L23-D022: 4-Hills Channel repairs for Beehive Homes Drainage Connection (SO-19)

Subject: 4-Hills Channel repairs

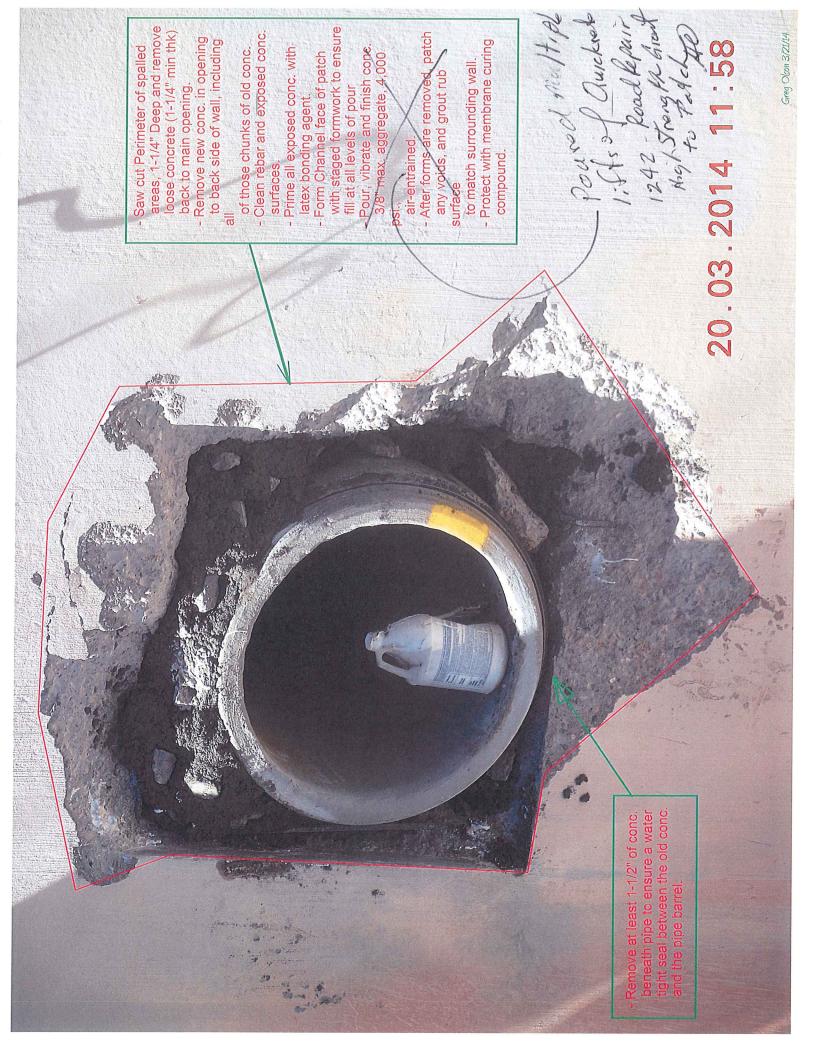
Concerns that I have are:

- 1. Strength of the retaining wall following all this action
- 2. Water tight seal of the penetration.
- 3. Long term durability of the patch work around the spalled opening.

In the mean time, I wanted to be thinking of what we would be willing to accept, short of complete removal of the wall section.

What are your thoughts and recommendations on repairs.

Attached is some sketching on one of Jason's photos, with some of my ideas.
